October 5, 2023  
File No.: 151510.1002

**Re: Proposed Upper's Quarry**  
**File No. ROPA-21-0003**  
**Letter of Concern – Rudanco Hospitality Corporation**

**ATTACHMENT 1:** *First Concept Plan*

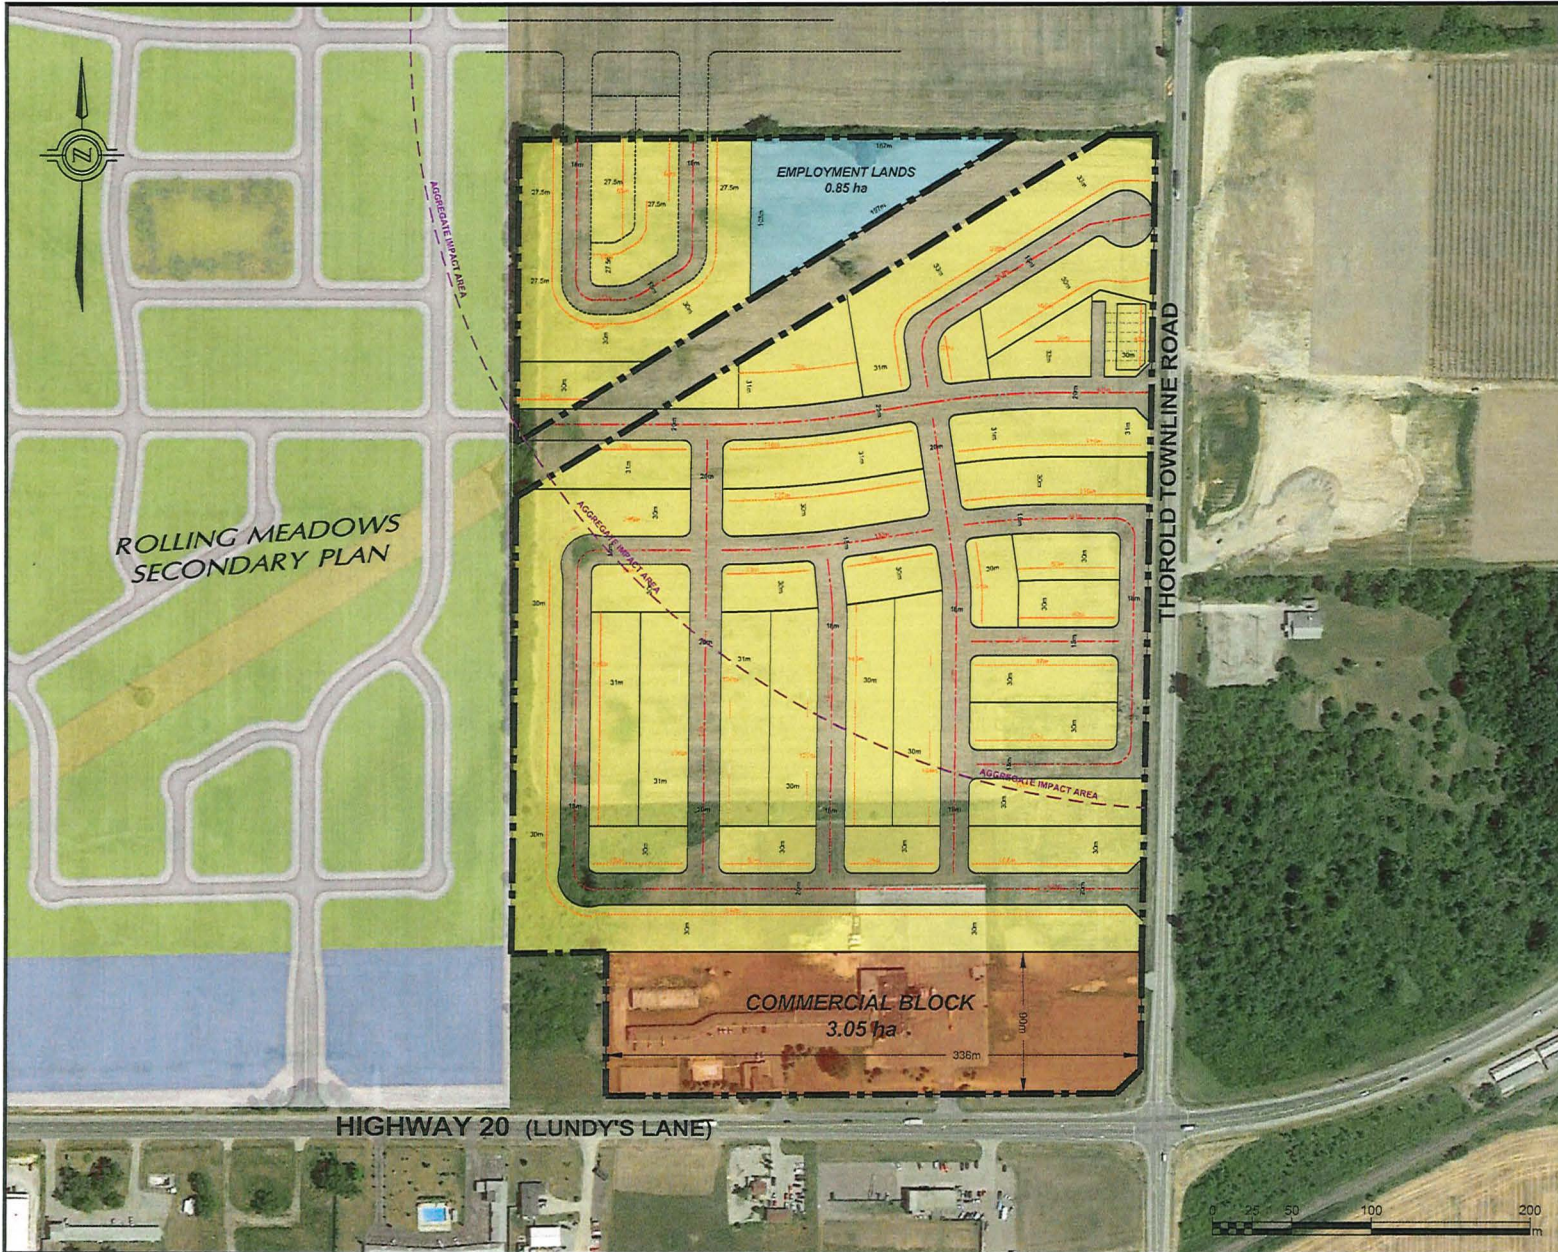
- The 'U' shaped road at the north end of the proposal shows connections to the land to the north. There is no draft approval on these lands, and therefore nothing for this to connect to. The Draft Plan should be redesigned to ensure there are existing and draft approved connections, OR this "U" shaped road will need to be approved through a separate application once there is a clear connection.
